# FINAL ENVIRONMENTAL IMPACT REPORT FOR THE SAN DIEGO COUNTY WATER AUTHORITY MISSION TRAILS FRS II, PIPELINE TUNNEL, AND VENT DEMOLITION PROJECT SCH#2005041025

VOLUME 3 OF 3 Comments, Responses to Comments, and Errata August 2006

COMMENTS, RESPONSES TO COMMENTS, AND ERRATA

SDUSD Property Boundary/Proposed FRS II Boundary

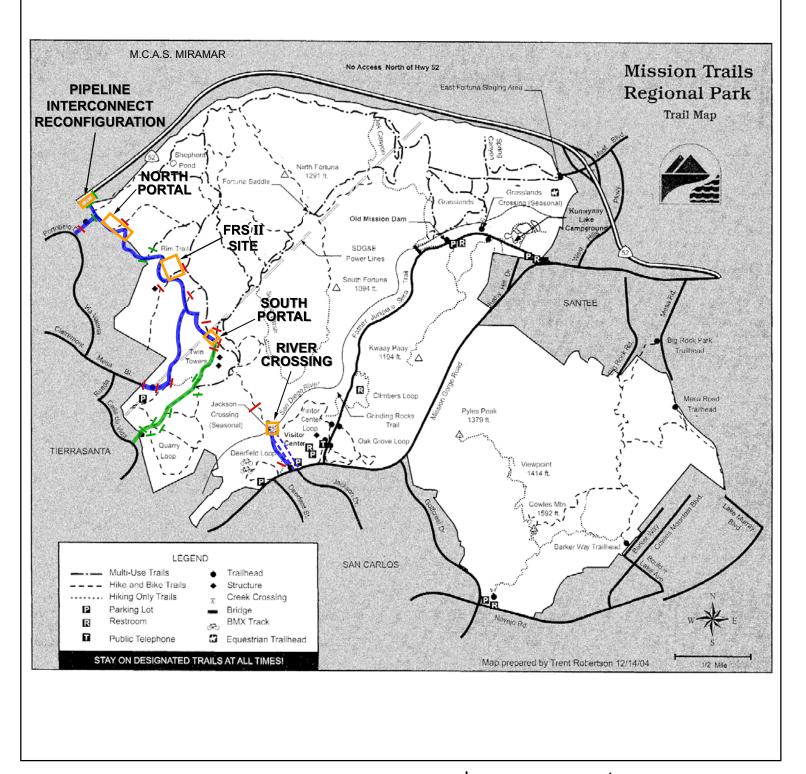
- Page 2-41, Figure 2-5 has been revised to more clearly identify the FRS I and FRS II property, and the City of San Diego property that is located between the San Diego Unified School District's property (proposed FRS II site) and the Water Authority's right-of-way. (see revised Figure 2-5, attached)
